S4.55 MODIFICATION - LIST OF CHANGES

DWG NO.	ARCHITECTURAL DRAWING NAME	ISSUE	REVISION	DATE ISSUED
GENERAL				
DA.1	TITLE PAGE & ROOF/SITE PLAN	MOD	L	11.08.2025
DA.2	EXISTING LOWER GROUND FLOOR DEMOLITION PLAN			
DA.3	EXISTING GROUND FLOOR DEMOLITION PLAN			
DA.4	EXISTING FIRST FLOOR DEMOLITION PLAN			
DA.5	EXISTING ROOF TERRACE DEMOLITION PLAN			
DA.6	PROPOSED LOWER GROUND FLOOR PLAN			
DA.7	PROPOSED GROUND FLOOR PLAN			
DA.8	PROPOSED FIRST FLOOR PLAN			
DA.9	PROPOSED ROOF TERRACE PLAN [AS IS]			
DA.10	SECTION X-X & Y-Y			
DA.11	NORTH & WEST ELEVATIONS			
DA.12	SOUTH & EAST ELEVATIONS			
~~DA.13~~	~~NEW VEHICLE CROSSING PLAN & SECTION~~			
A.100	AREA CALCULATION PLANS			
LA.001	LANDSCAPE PLANS

DRAWING STATUS:
MODIFICATION APPLICATION

HOUSE DELANEY
Alterations & Additions to Existing House
BCA Class 1a
39 Heathcliff Crescent, Balgowlah Heights
Lot 16 Sec 25 D.P. #758044
SITE AREA 617.4m²

PROPOSED
First Floor Plan
SCALE 1:100/A2

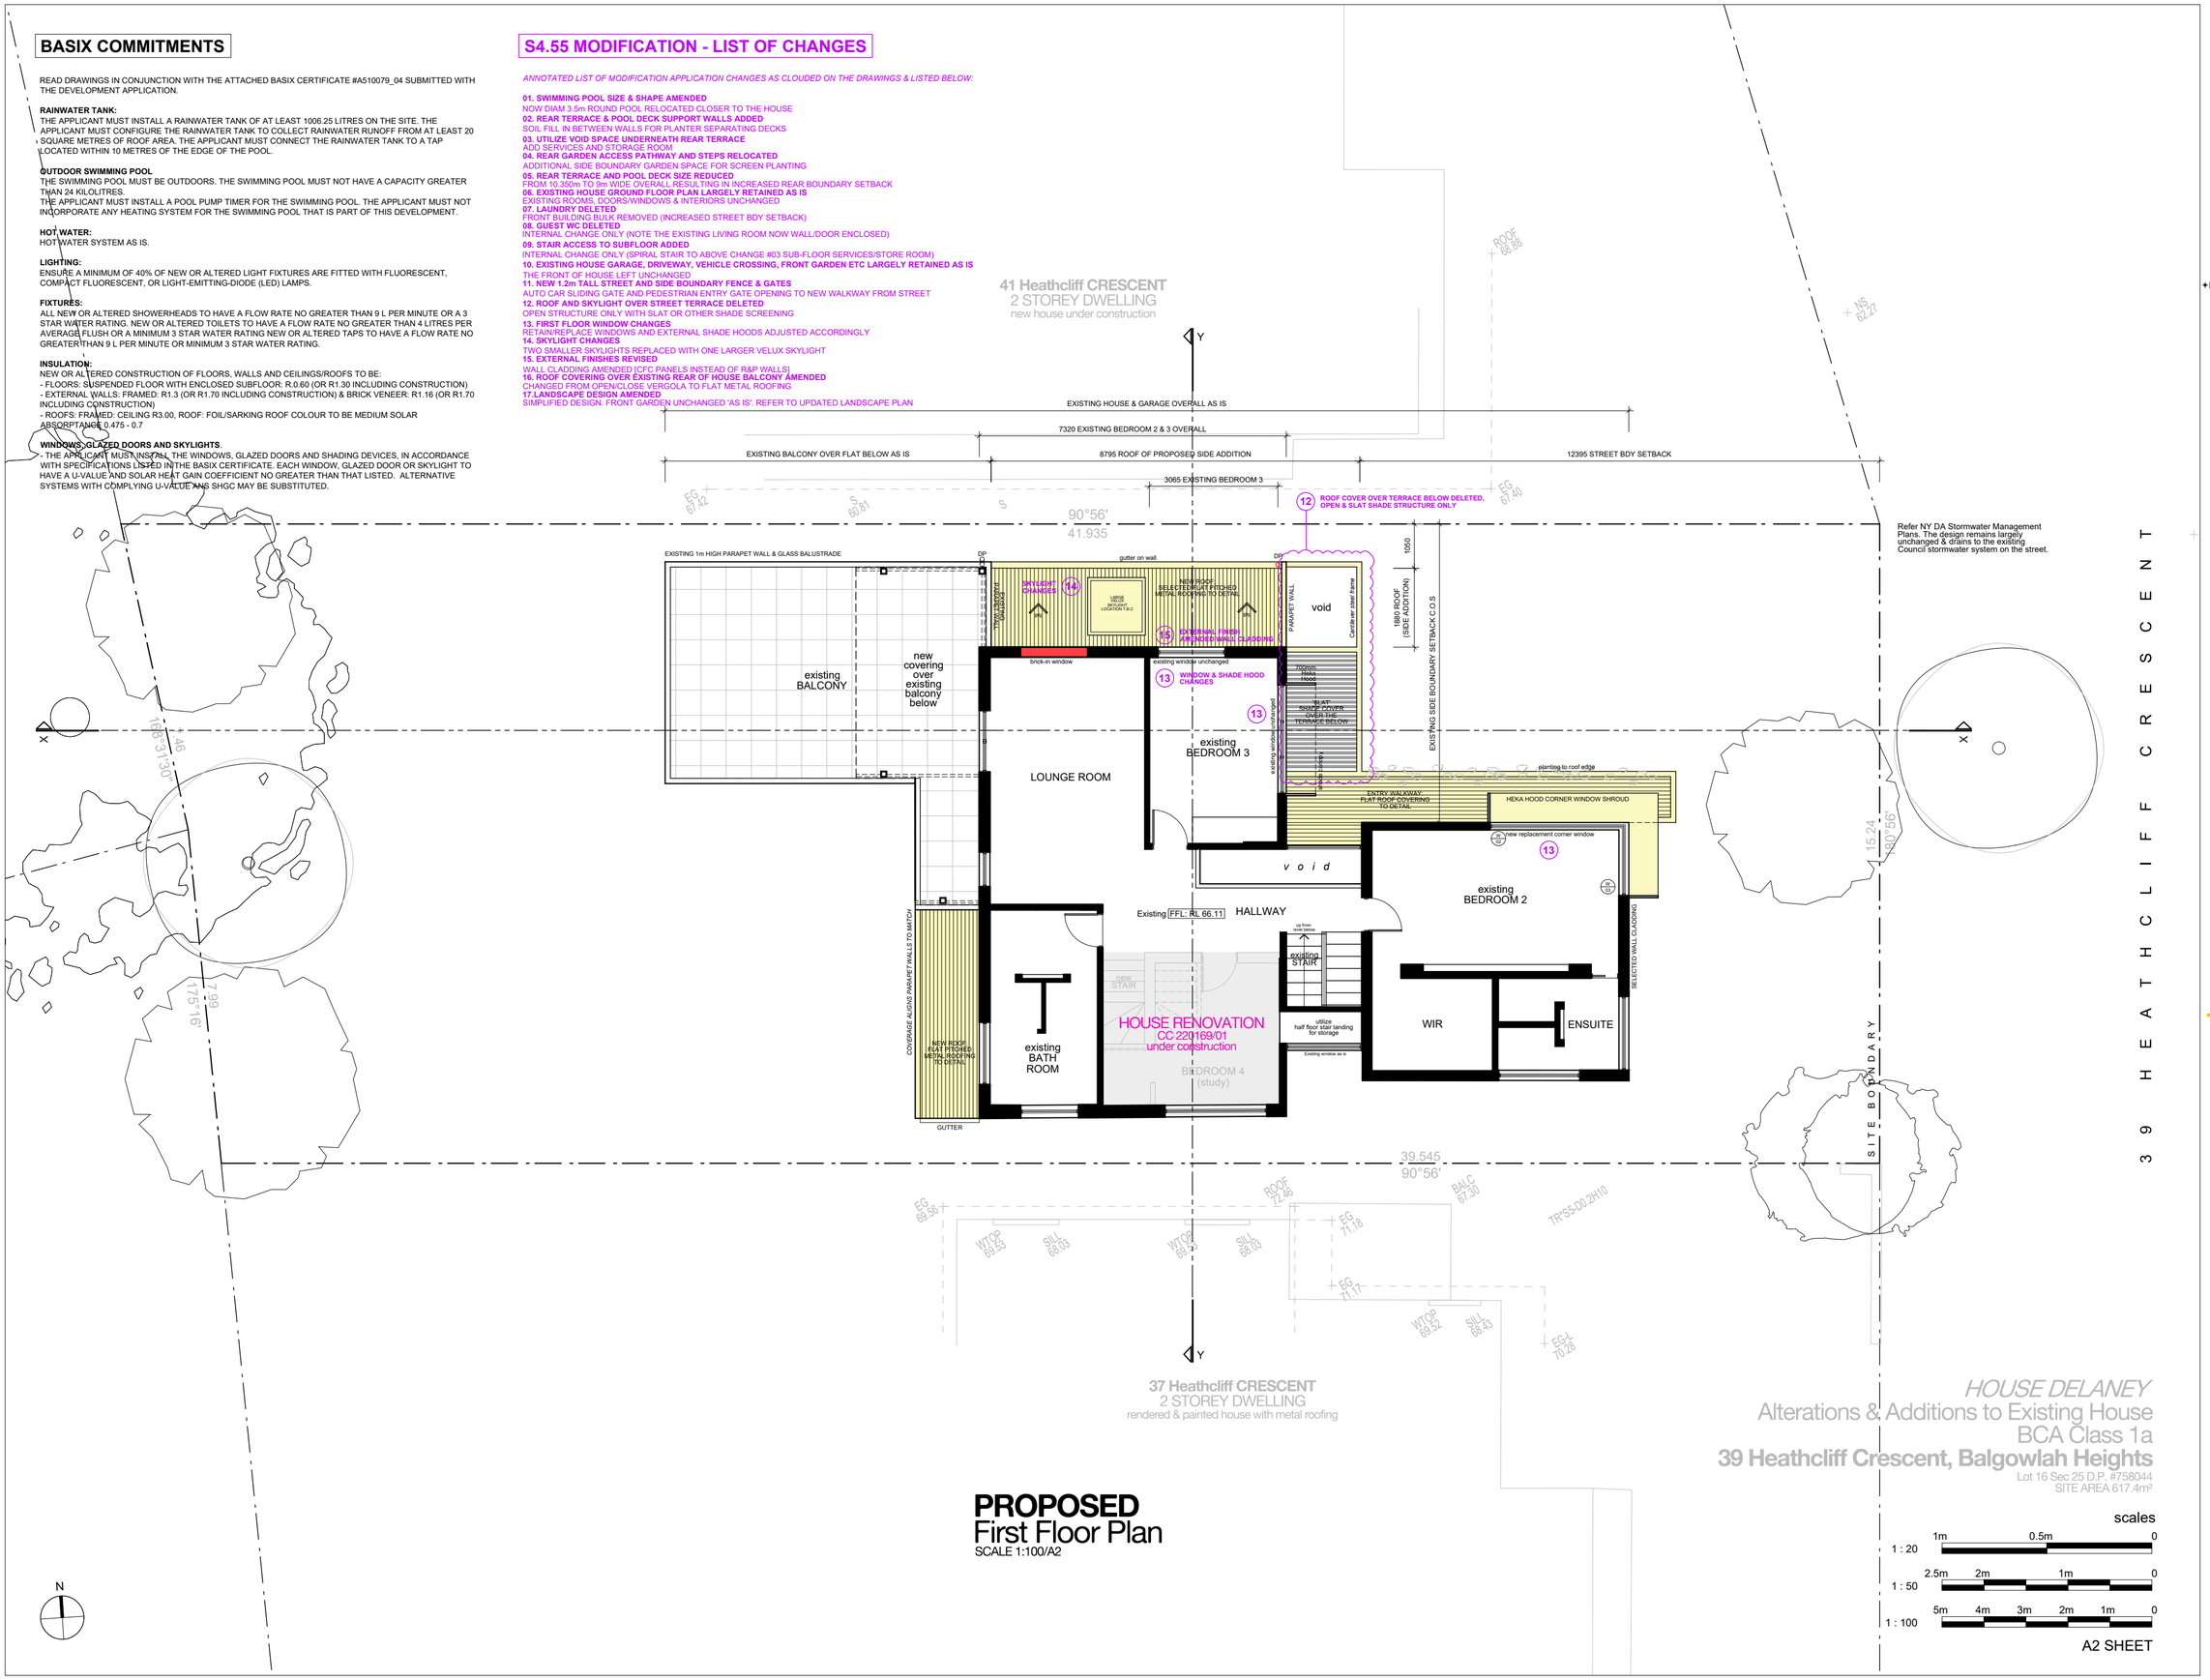
01. SWIMMING POOL SIZE & SHAPE AMENDED
NOW DIAM 3.5m ROUND POOL RELOCATED CLOSER TO THE HOUSE
02. REAR TERRACE & POOL DECK SUPPORT WALLS ADDED
SOIL FILL IN BETWEEN WALLS FOR PLANTER SEPARATING DECKS

03. UTILIZE VOID SPACE UNDERNEATH REAR TERRACE
ADD SERVICES AND STORAGE ROOM
04. REAR GARDEN ACCESS PATHWAY AND STEPS RELOCATED
ADDITIONAL SIDE BOUNDARY GARDEN SPACE FOR SCREEN PLANTING

05. REAR TERRACE AND POOL DECK SIZE REDUCED
FROM 10.350m TO 9m WIDE OVERALL RESULTING IN INCREASED REAR BOUNDARY SETBACK
06. EXISTING HOUSE GROUND FLOOR PLAN LARGELY RETAINED AS IS
EXISTING ROOMS, DOORS/WINDOWS & INTERIORS UNCHANGED

07. LAUNDRY DELETED
FRONT BUILDING BULK REMOVED (INCREASED STREET BDY SETBACK)
08. GUEST WC DELETED
INTERNAL CHANGE ONLY (NOTE THE EXISTING LIVING ROOM NOW WALL/DOOR ENCLOSED)

09. STAIR ACCESS TO SUBFLOOR ADDED
INTERNAL CHANGE ONLY (SPIRAL STAIR TO ABOVE CHANGE #03 SUB-FLOOR SERVICES/STORE ROOM)
10. EXISTING HOUSE GARAGE, DRIVEWAY, VEHICLE CROSSING, FRONT GARDEN ETC LARGELY RETAINED AS IS
THE FRONT OF HOUSE LEFT UNCHANGED

13. FIRST FLOOR WINDOW CHANGES
RETAIN/REPLACE WINDOWS AND EXTERNAL SHADE HOODS ADJUSTED ACCORDINGLY
14. SKYLIGHT CHANGES
TWO SMALLER SKYLIGHTS REPLACED WITH ONE LARGER VELUX SKYLIGHT

15. EXTERNAL FINISHES REVISED
WALL CLADDING AMENDED [CFC PANELS INSTEAD OF R&P WALLS]
16. ROOF COVERING OVER EXISTING REAR OF HOUSE BALCONY AMENDED
CHANGED FROM OPEN/CLOSE VERGOLA TO FLAT METAL ROOFING

DRAWING TITLE:
ROOF
TERRACE PLAN

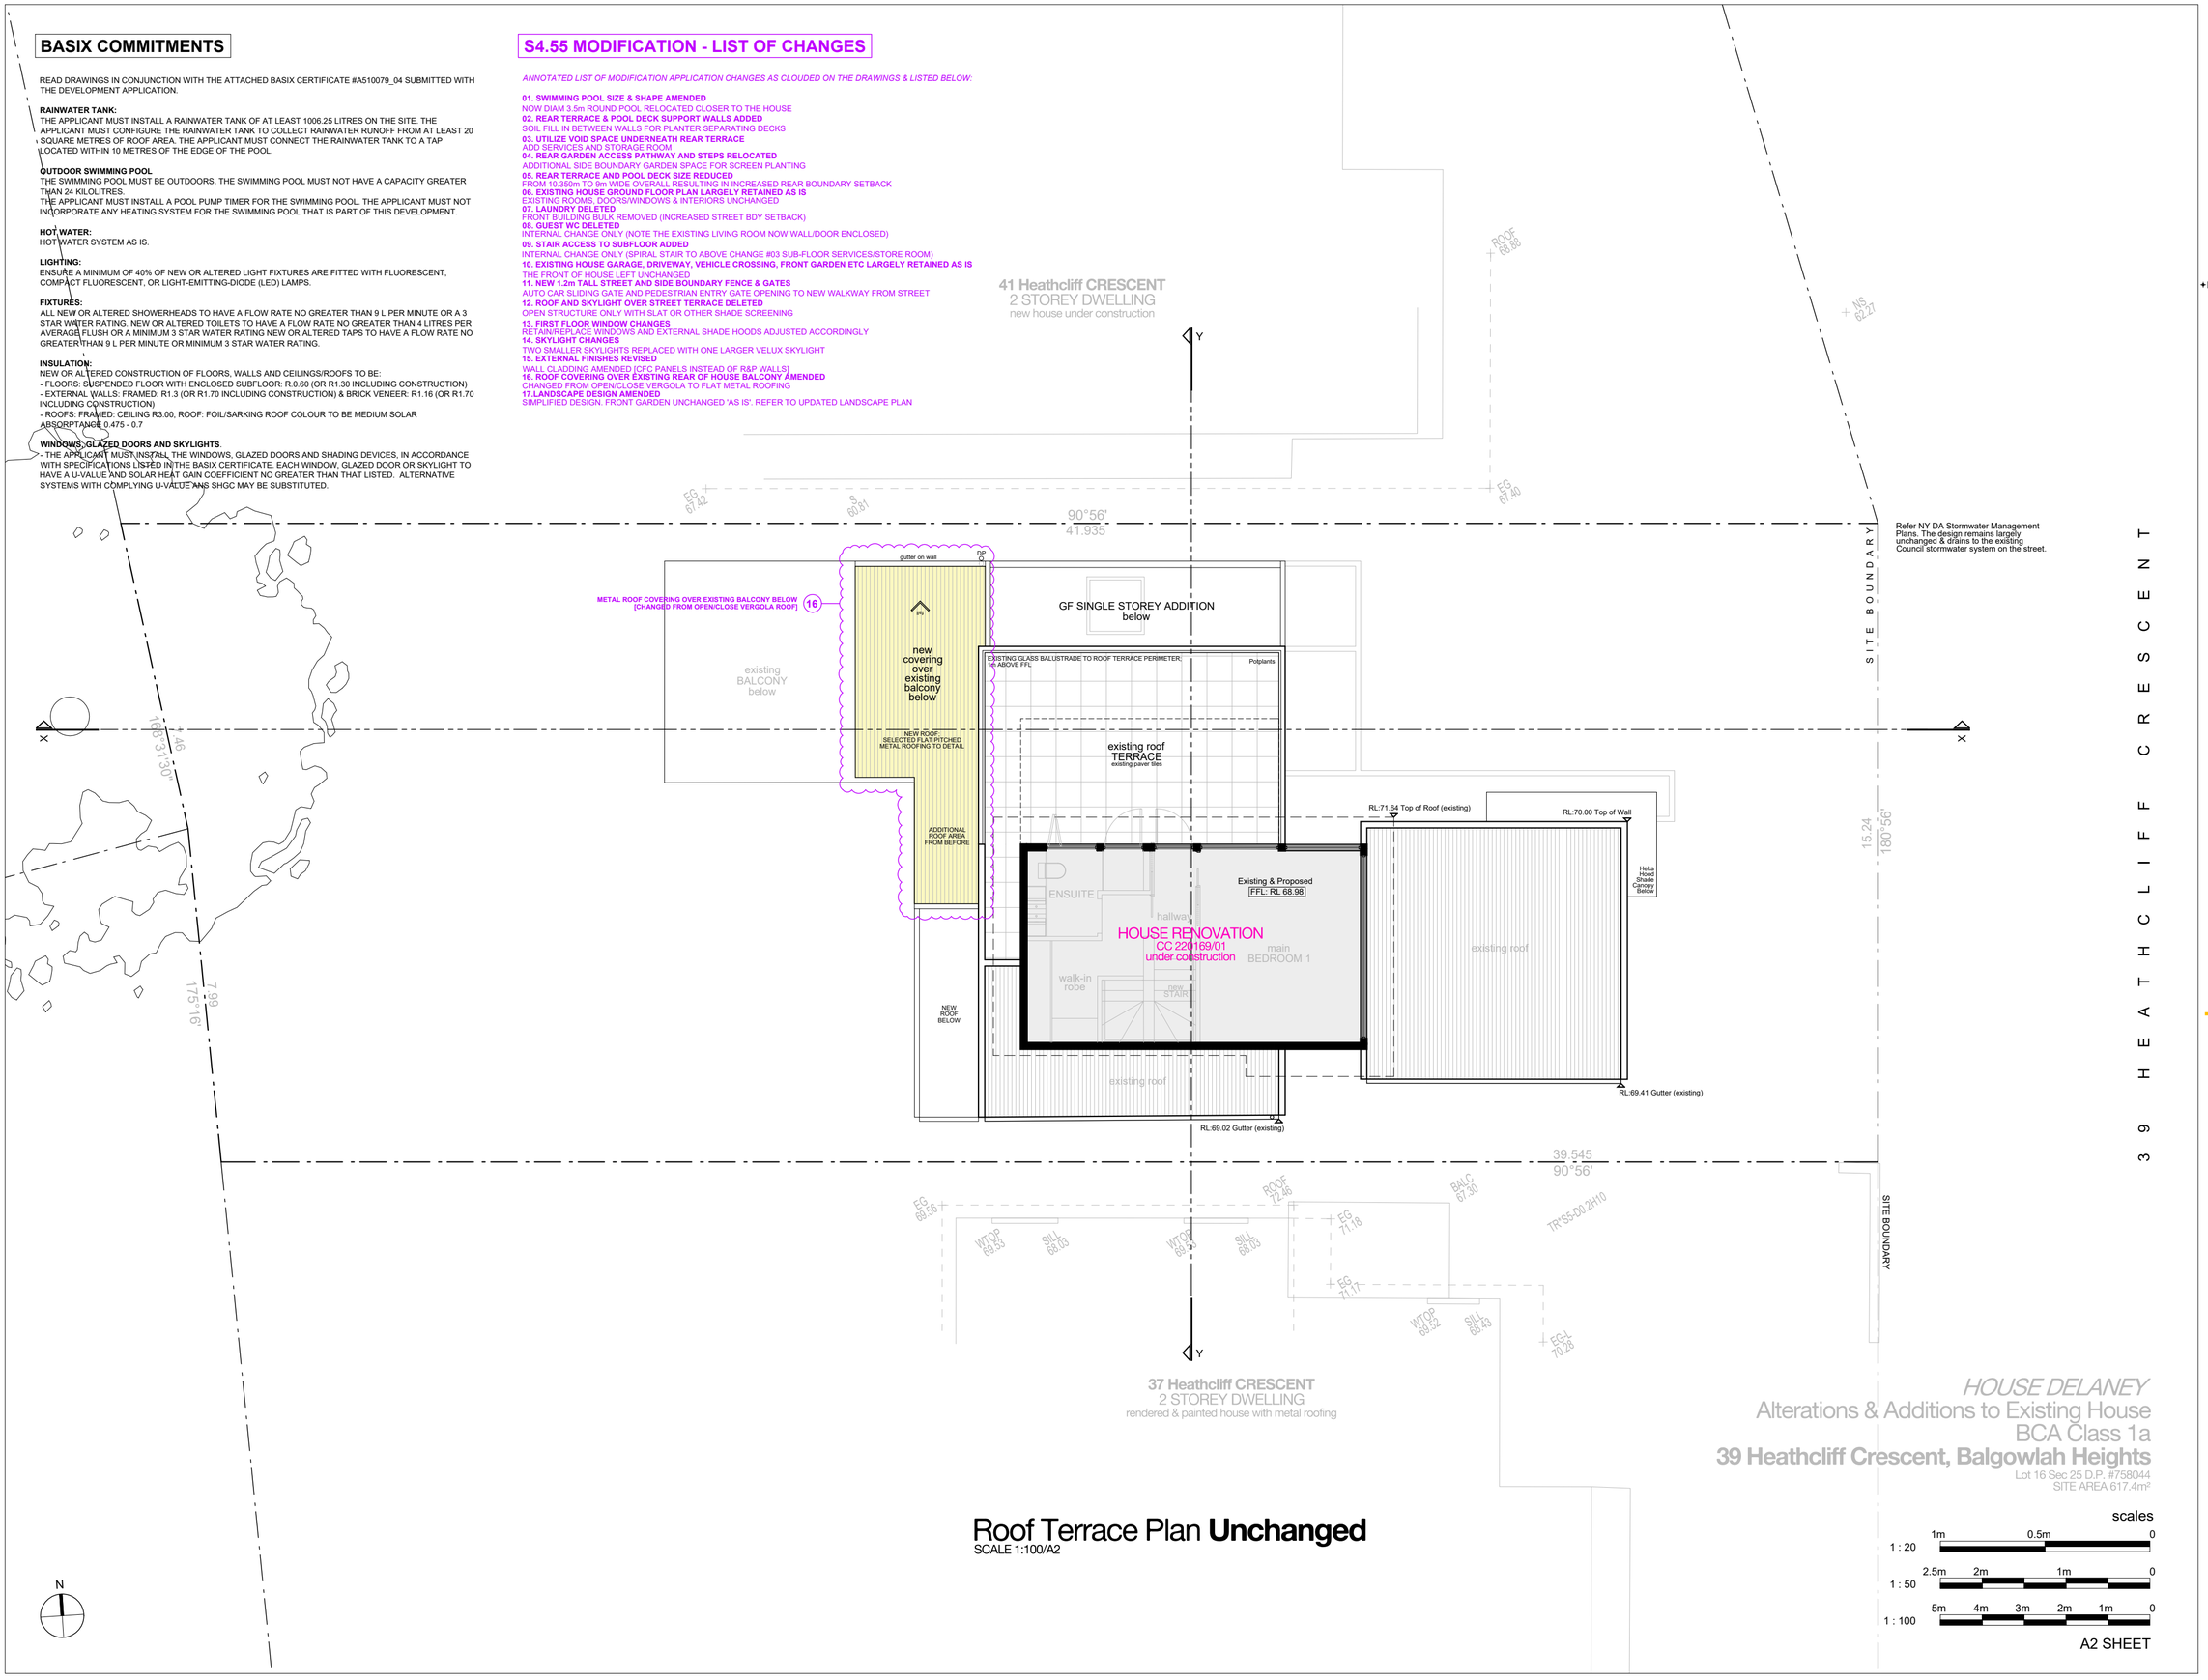
01. SWIMMING POOL SIZE & SHAPE AMENDED
NOW DIAM 3.5m ROUND POOL RELOCATED CLOSER TO THE HOUSE
02. REAR TERRACE & POOL DECK SUPPORT WALLS ADDED
SOIL FILL IN BETWEEN WALLS FOR PLANTER SEPARATING DECKS

03. UTILIZE VOID SPACE UNDERNEATH REAR TERRACE
ADD SERVICES AND STORAGE ROOM
04. REAR GARDEN ACCESS PATHWAY AND STEPS RELOCATED
ADDITIONAL SIDE BOUNDARY GARDEN SPACE FOR SCREEN PLANTING

05. REAR TERRACE AND POOL DECK SIZE REDUCED
FROM 10.350m TO 9m WIDE OVERALL RESULTING IN INCREASED REAR BOUNDARY SETBACK
06. EXISTING HOUSE GROUND FLOOR PLAN LARGELY RETAINED AS IS
EXISTING ROOMS, DOORS/WINDOWS & INTERIORS UNCHANGED

07. LAUNDRY DELETED
FRONT BUILDING BULK REMOVED (INCREASED STREET BDY SETBACK)
08. GUEST WC DELETED
INTERNAL CHANGE ONLY (NOTE THE EXISTING LIVING ROOM NOW WALL/DOOR ENCLOSED)

09. STAIR ACCESS TO SUBFLOOR ADDED
INTERNAL CHANGE ONLY (SPIRAL STAIR TO ABOVE CHANGE #03 SUB-FLOOR SERVICES/STORE ROOM)
10. EXISTING HOUSE GARAGE, DRIVEWAY, VEHICLE CROSSING, FRONT GARDEN ETC LARGELY RETAINED AS IS
THE FRONT OF HOUSE LEFT UNCHANGED

13. FIRST FLOOR WINDOW CHANGES
RETAIN/REPLACE WINDOWS AND EXTERNAL SHADE HOODS ADJUSTED ACCORDINGLY
14. SKYLIGHT CHANGES
TWO SMALLER SKYLIGHTS REPLACED WITH ONE LARGER VELUX SKYLIGHT

15. EXTERNAL FINISHES REVISED
WALL CLADDING AMENDED [CFC PANELS INSTEAD OF R&P WALLS]
16. ROOF COVERING OVER EXISTING REAR OF HOUSE BALCONY AMENDED
CHANGED FROM OPEN/CLOSE VERGOLA TO FLAT METAL ROOFING
